Access Compliance Report

Public Rights-of-Way

(Pedestrian Signals)

Intersection ID: N/A	Main Street:	Cross Street: N/A	Location: N/A
ADA ID: 236EC50516D0	Signal Type: One Push Button-Non APS	Overall Compliance: No	Severity Score: BTN 1: N/A BTN 2: N/A No BTN: N/A
Codes/Mitigation Info/Possible Solution		Field Measurements/Component Compliance

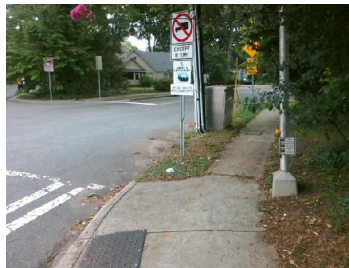
PROW/ADA: TMUTCD 4e.08, R404.2, R404.3, R406.2

Possible Solutions: Replace Signal Push Button With APS Button on New Post. Remove & Relocate Sign.
